SANDSTONE PRECINCT

23-39 BRIDGE STREET
SYDNEY NSW, 2000

**PROPOSED PLANS - LANDS BUILDING -
LOWER GROUND, EDUCATION BUILDING -
BASEMENT 01**

FOR APPROVAL

TITLE
FACADE DETAILS - EDUCATION BUILDING - GARDEN VILLA

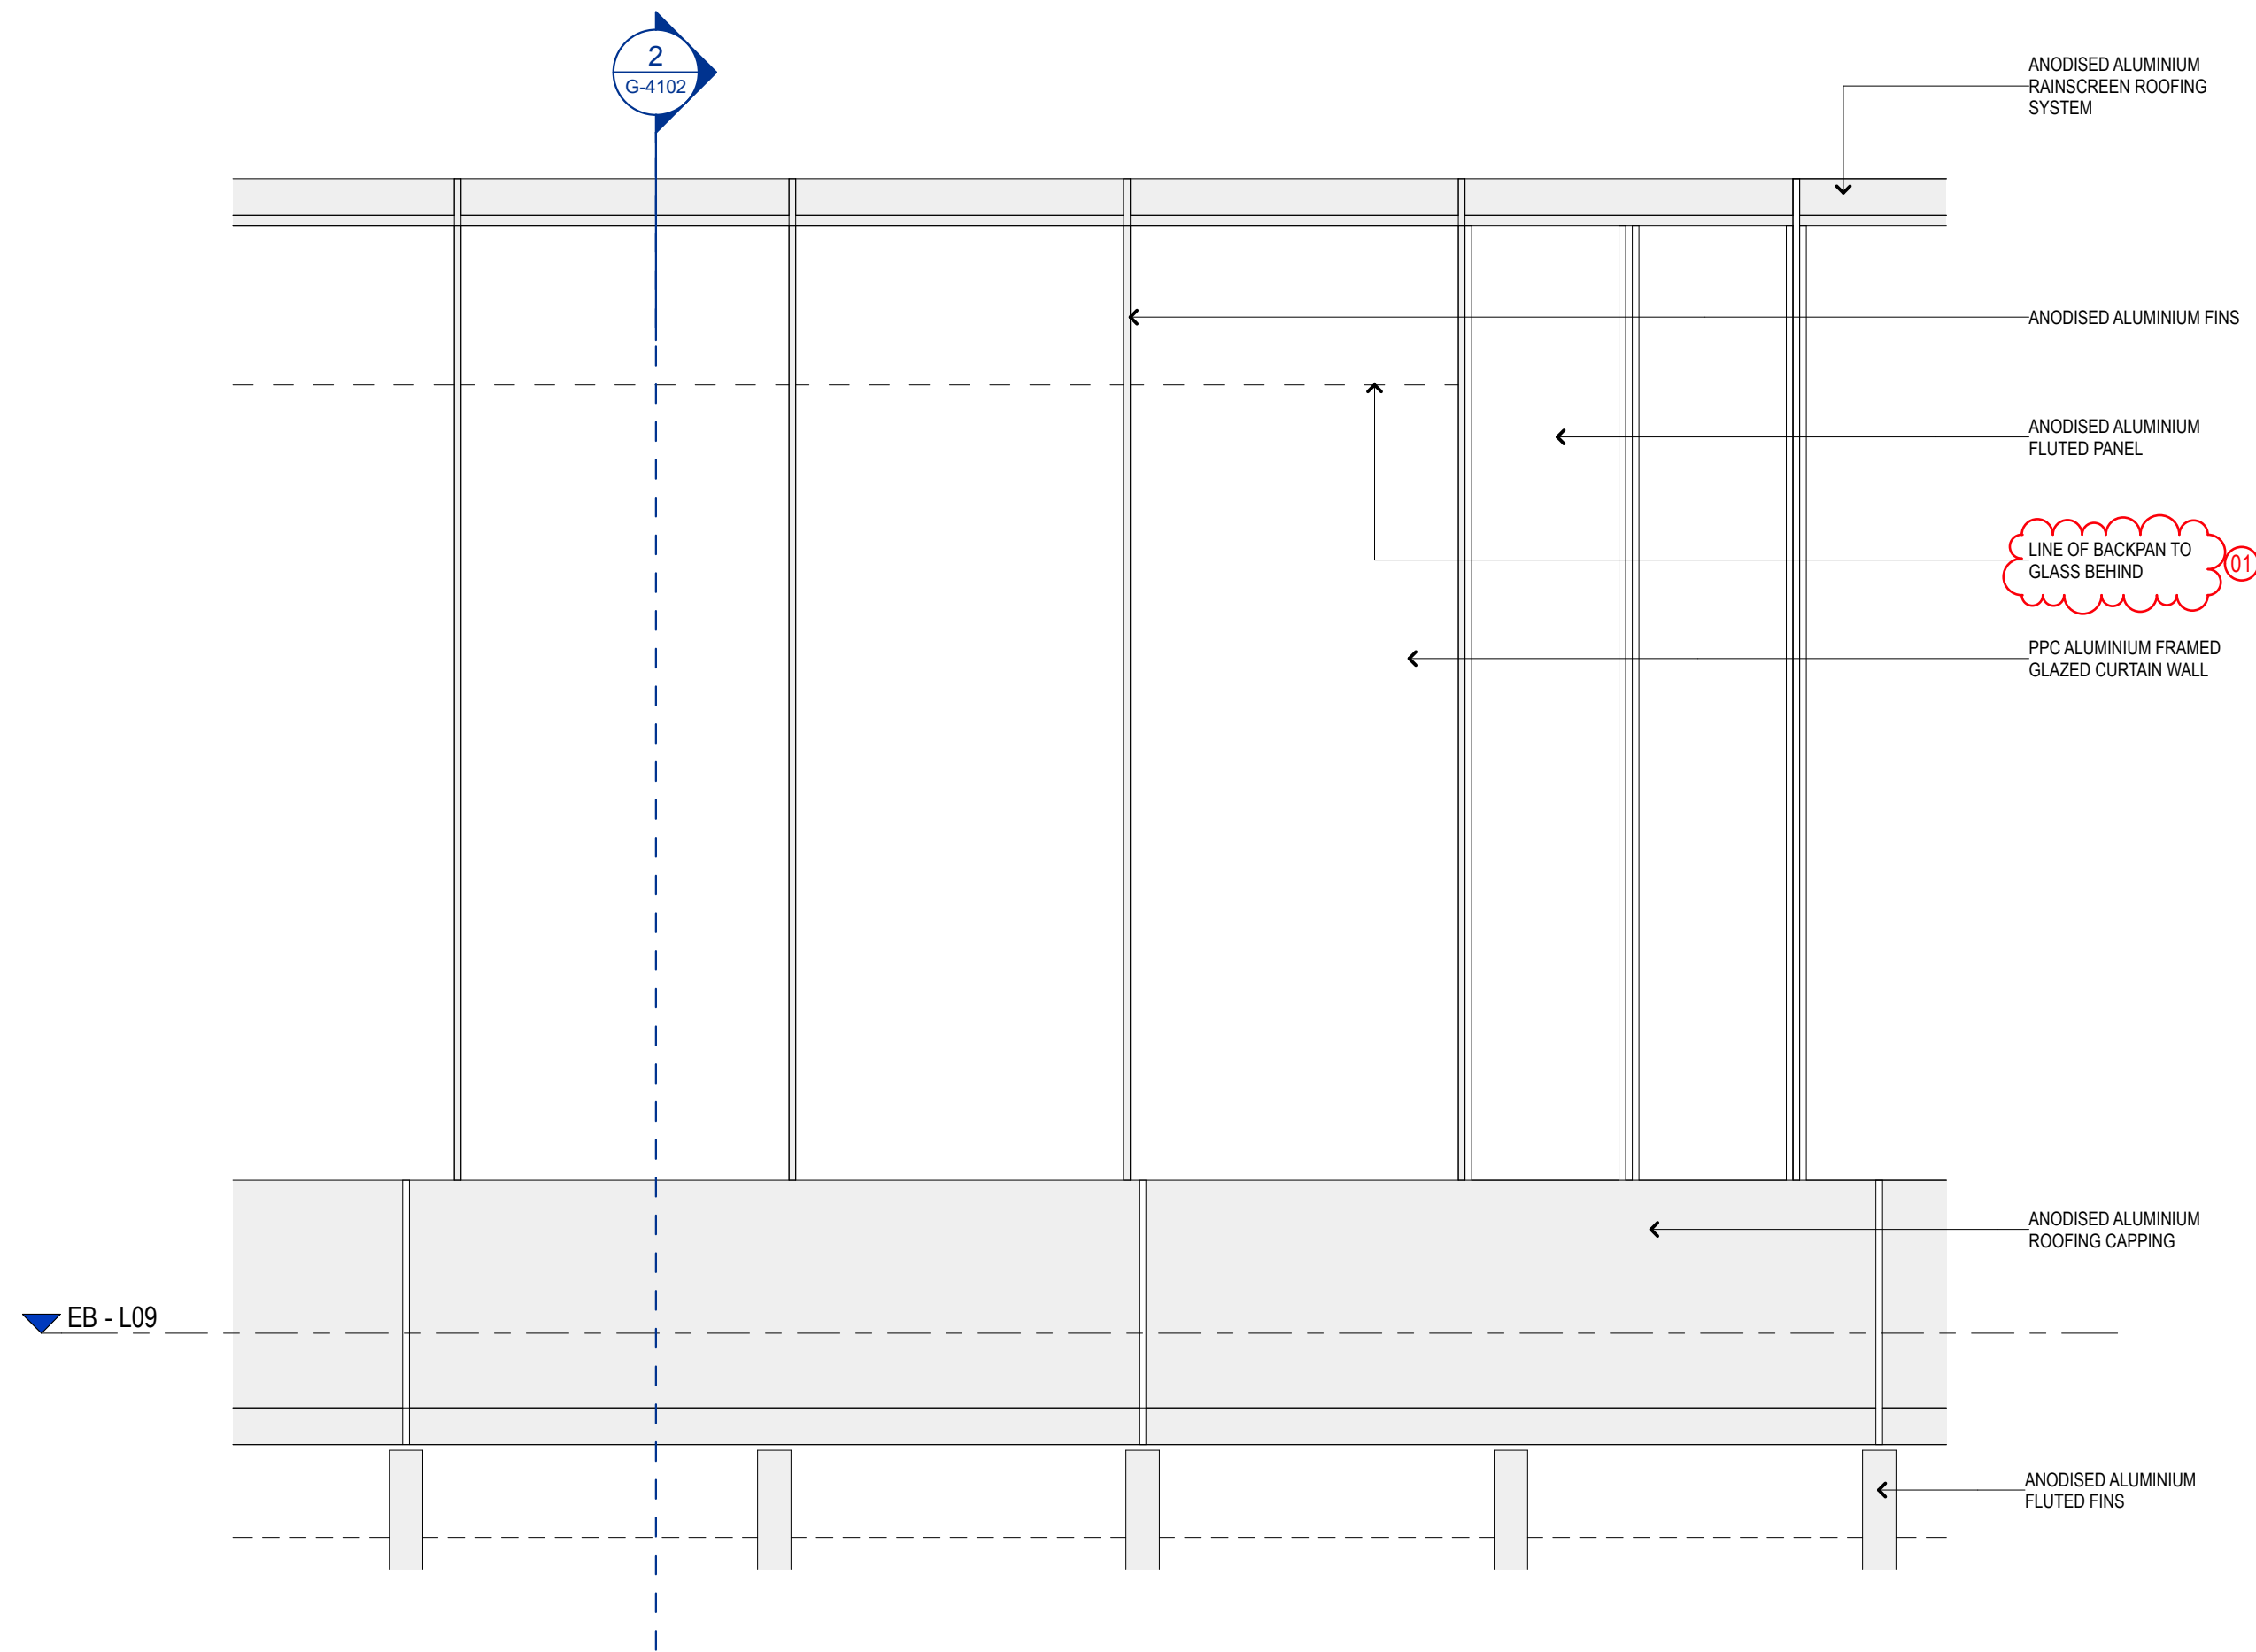
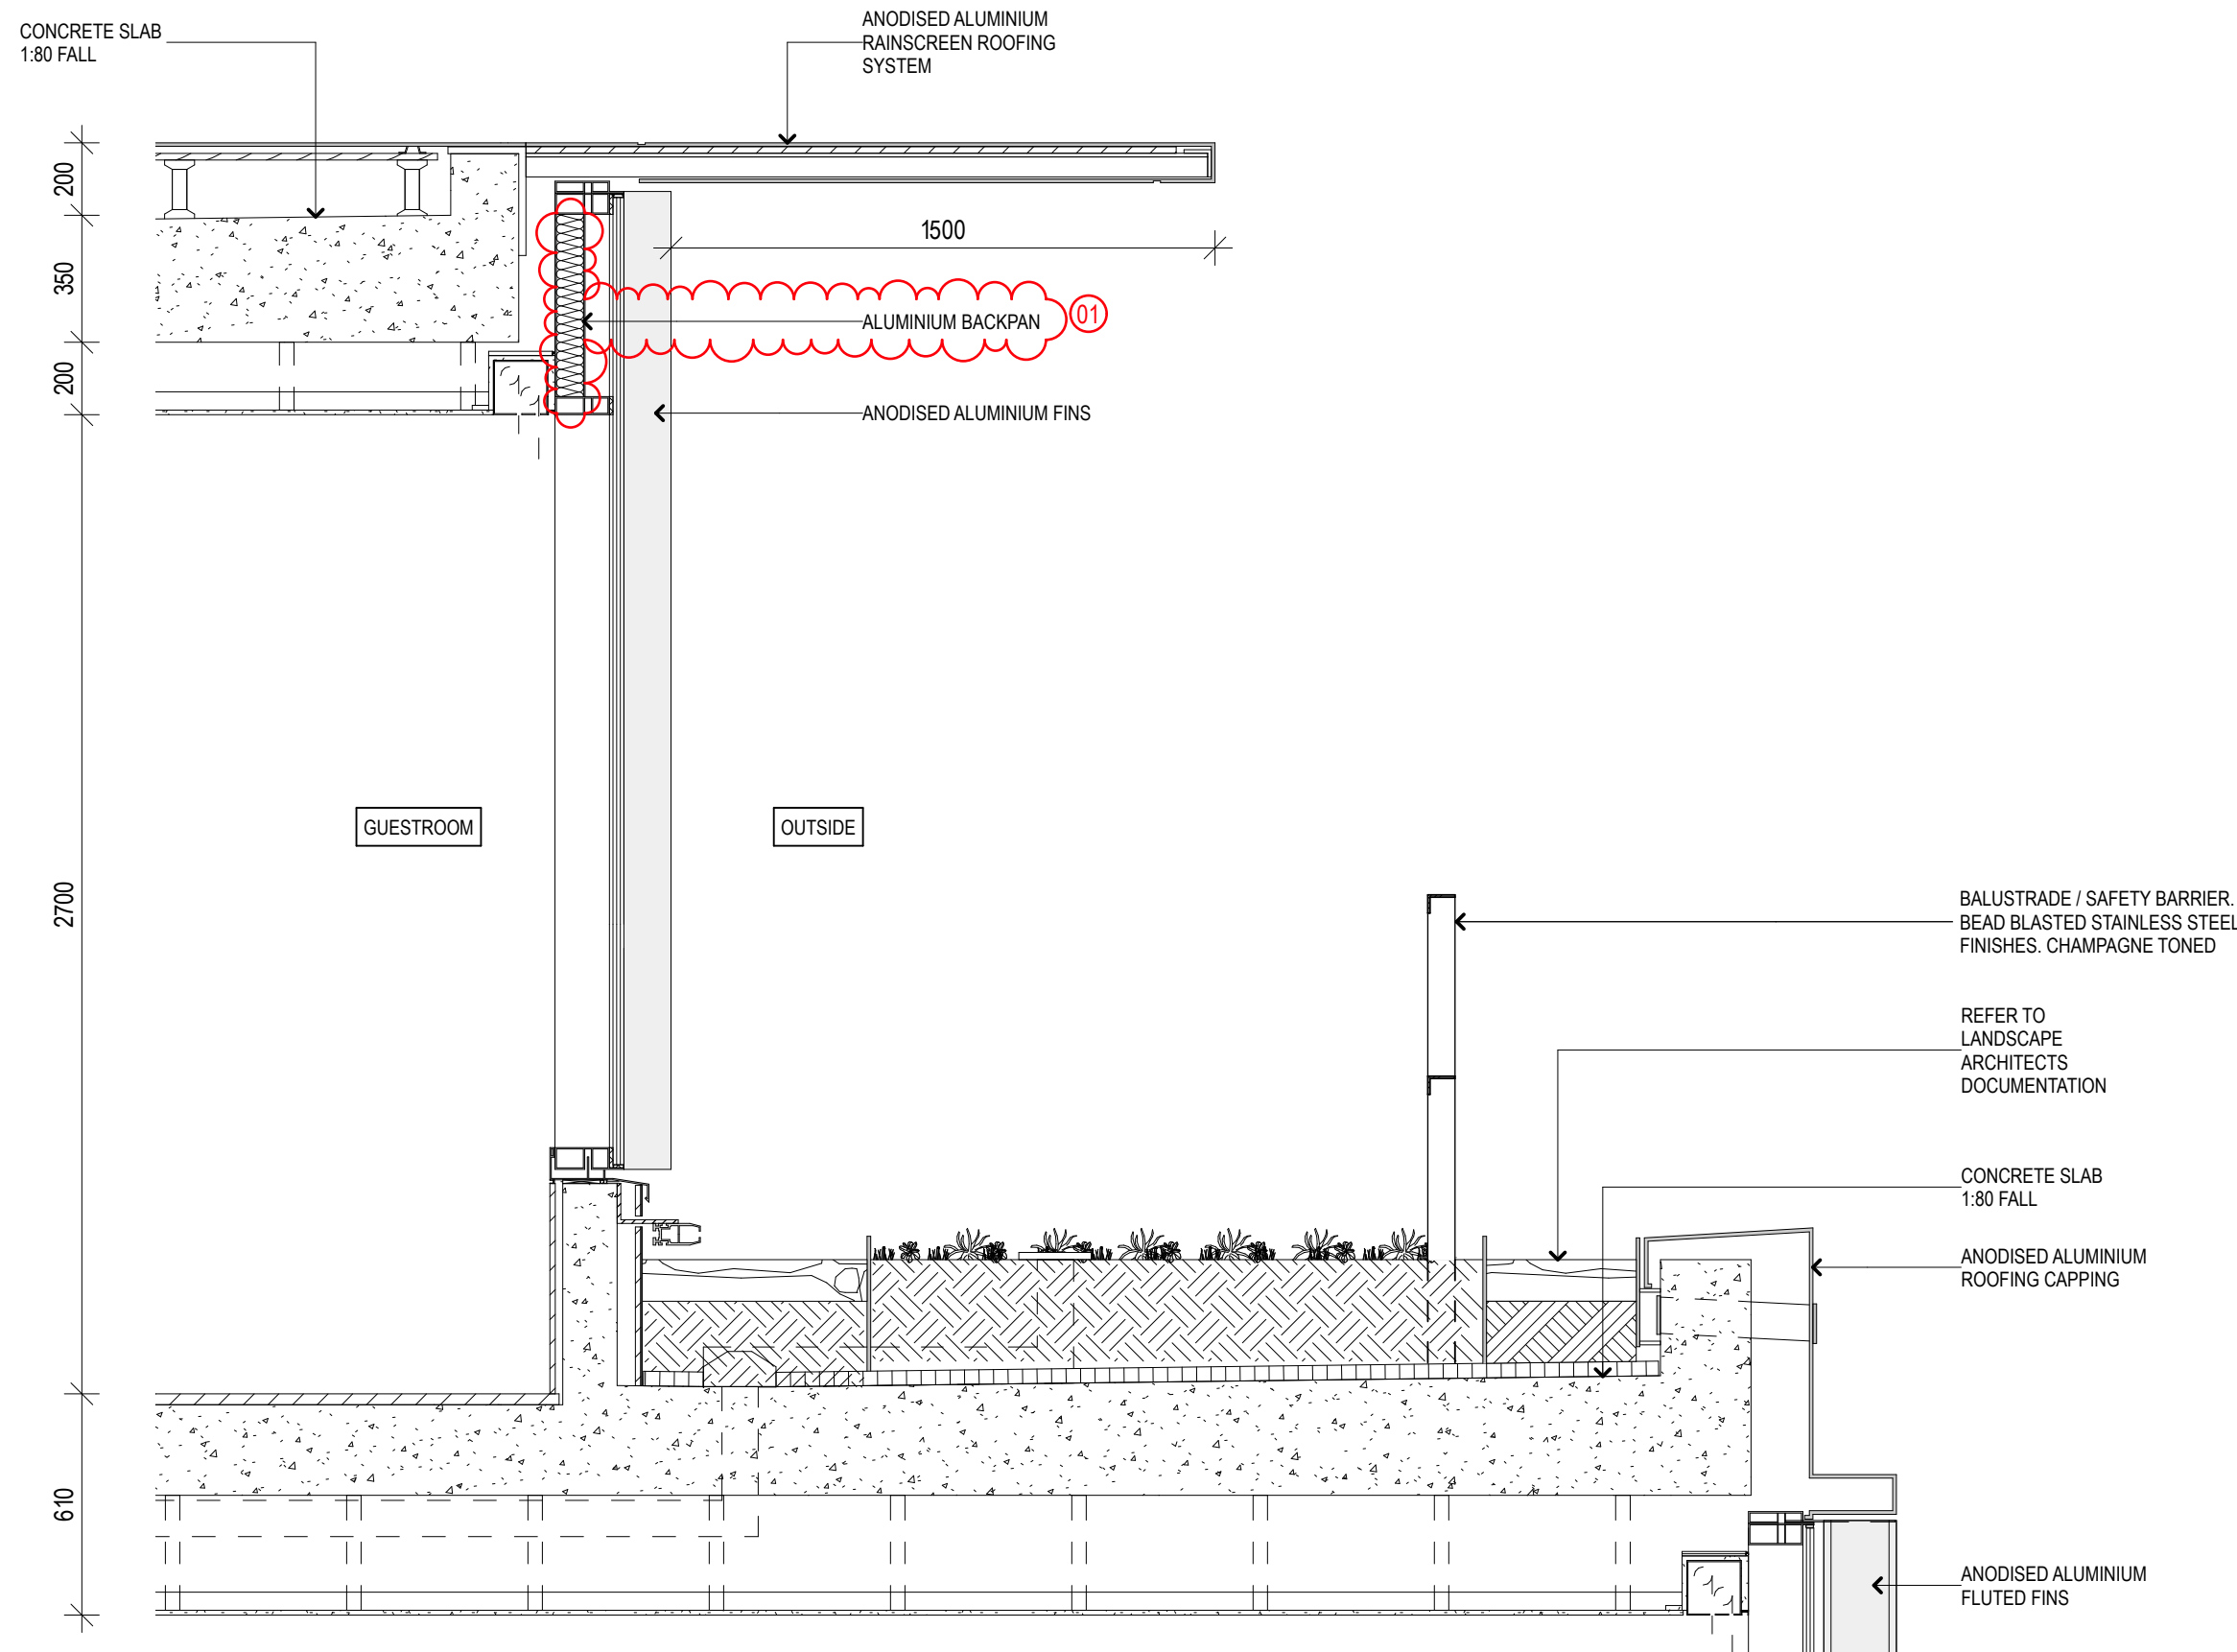
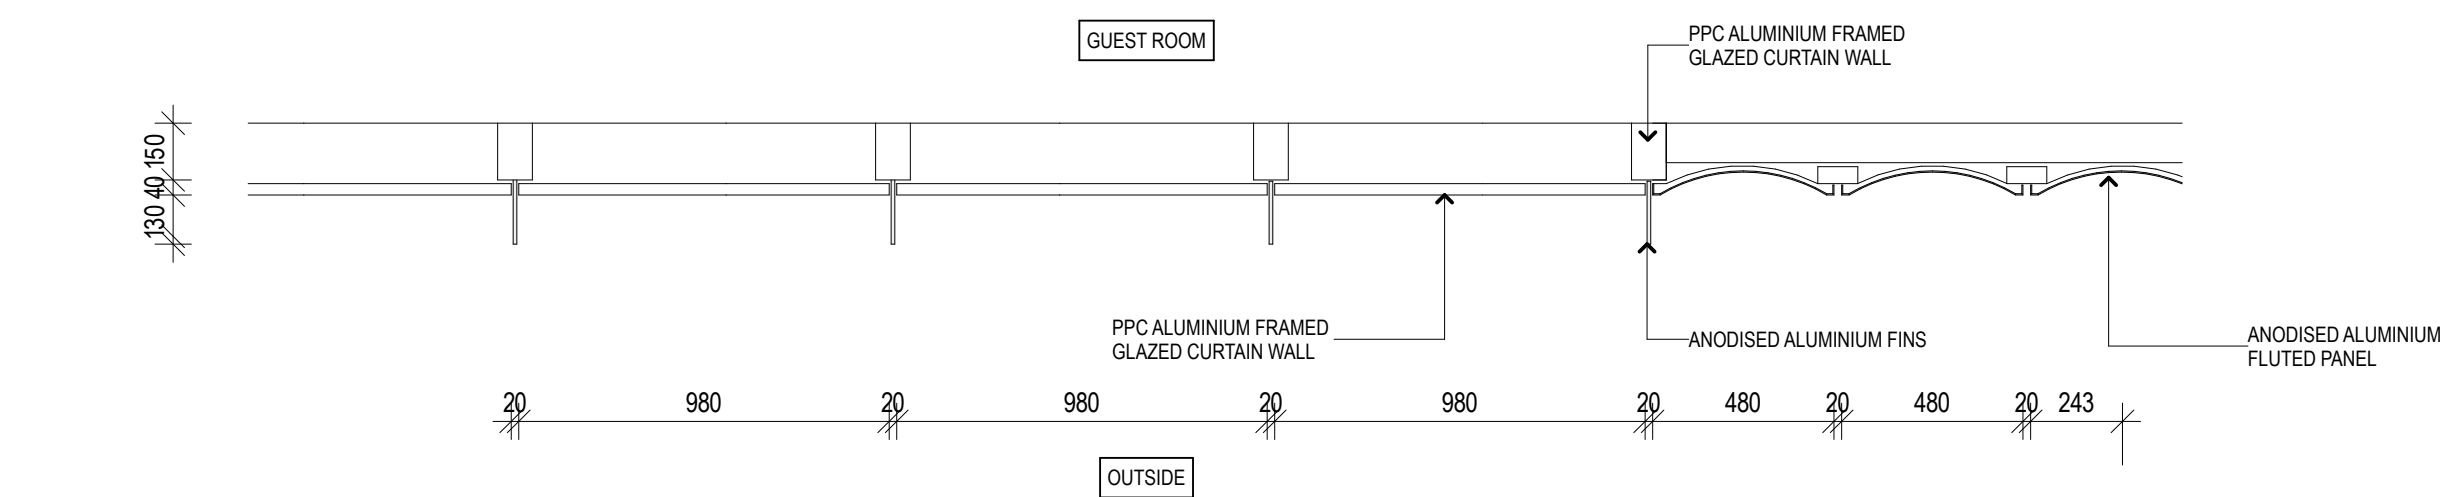
| 01 | ADDED BACKSPAN ABOVE CEILING LEVEL |
